**Comments on the Final Environmental Impact Statement  
for the  
Northern Integrated Supply Project**

**Dated: October 4, 2018**

The City of Fort Collins (“Fort Collins”) respectfully submits to the United States Army Corps of Engineers (“Corps”) these comments on Final Environmental Impact Statement, dated July 2018 and issued on July 20, 2018 (“FEIS”), and its associated technical reports and related documents, regarding the Northern Integrated Supply Project (“NISP” or “Project”) proposed by the applicant, the Northern Colorado Water Conservancy District (“Northern” or “District”). Reference materials are identified in the comments and the majority of such reference materials are being provided to the Corps in electronic format. These reference materials constitute part of these comments. Fort Collins reserves all rights to supplement these comments on the FEIS and/or NISP, as may be appropriate.

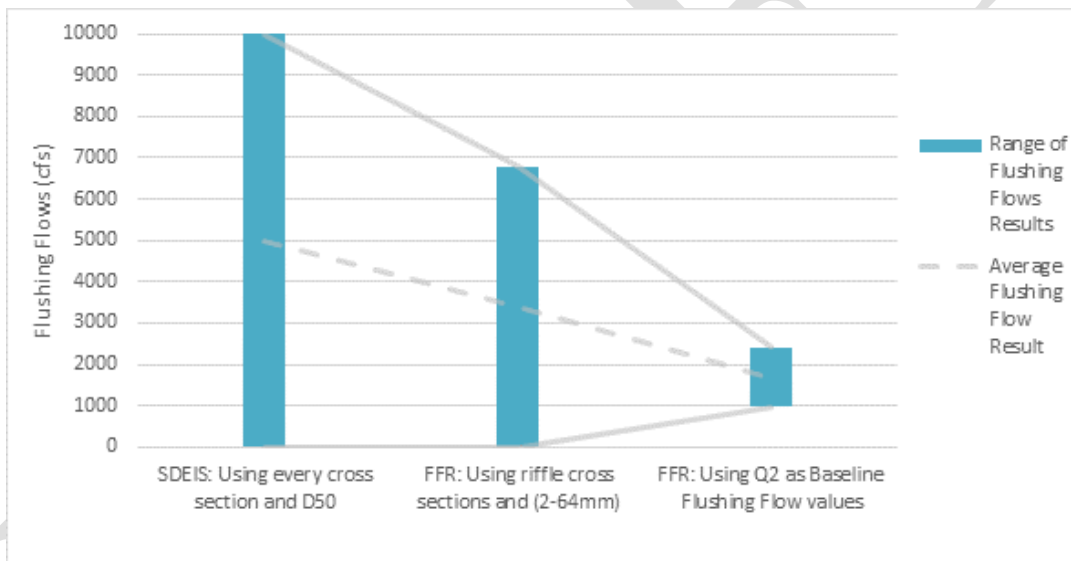
A wide range of flow magnitudes was used during the studies leading up to the FEIS and assumed to satisfy the flushing criteria. The figure below presents a graphic illustration of how the range of flows required to meet the selected definition of flushing flows changed throughout the process leading to the FEIS. (In this figure, “FFR” refers to Flushing Flows Report, 2017.) The range is ultimately a reflection of shifting definitions, changing assumptions, and an apparently arbitrary selection key values.

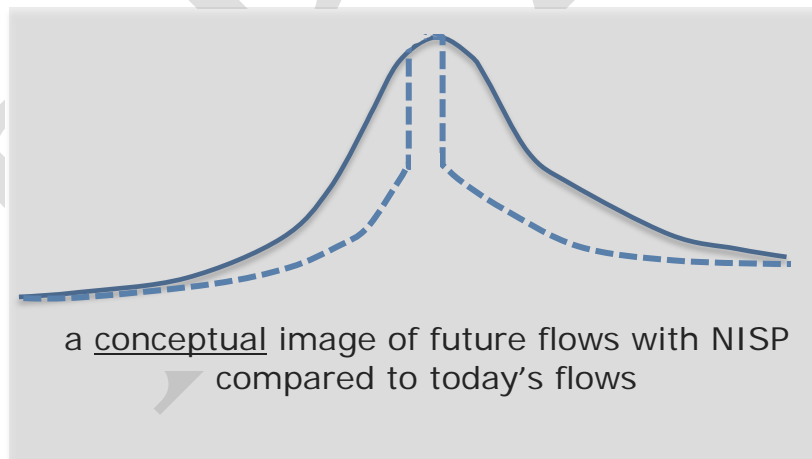
**Comment:** One of the key principles presented throughout the FEIS is that changing flows will affect Poudre River ecosystems and habitats. While Fort Collins appreciates the effort taken by Northern to develop the Peak Flow Operations Program, Fort Collins has two key concerns.

First, the Peak Flow Operations Plan is described in the 2017 Fish and Wildlife Mitigation and Enhancement Plan.<sup>2</sup> However, there is some uncertainty how certain aspects of the Peak Flow Operations Plan will be implemented, which results in uncertainty regarding how many peak flow bypasses will result. This leaves Fort Collins with uncertainty over the future hydrology and the degree to which flushing flows will occur. The following are examples of this uncertainty:

However, impacts to the Poudre River from such a modified descending limb are not analyzed in the FEIS. The conceptual image above is Fort Collins' current understanding of how NISP's peak flow operations Program may affect current flows. The impacts to the descending limb will shorten duration of peak flows which will result in impacts to geomorphology, riparian and wetland habitat. It may cause more rapid declines in river flow, which could preclude successful establishment of cottonwood seedling. Rapid declines in flow could also cause stranding of fish and affect critical life cycle behaviors such as spawning and migration patterns of the small native fish. It could reduce sediment transport and increase aggradation through Fort Collins which would result in increased flood risk. Last, if flows at the tail end of the descending limb are reduced, there will be a greater impact on boatable day. This makes it difficult to understand Project impacts and the sufficiency of mitigation.

Northern should be required to provide, at minimum, a complete three-day peak flow in all years. If the Peak Flow Operations Program remains in effect, Fort Collins requests clarification on the implementation and effects of the program, including how stream flows are required to be forecast and how the averages are to be calculated. Northern should also be required to annually publish notice of how the Peak Flow Operations Program was implemented. Northern should also be required perform additional mitigation to compensate for the apparent lack of analysis of the impacts resulting from increased diversions following the peak flow bypass period (under a complete three-day peak flow or something less under the Peak Flow Operations Program) to address the apparent lack of analyses of such impacts.
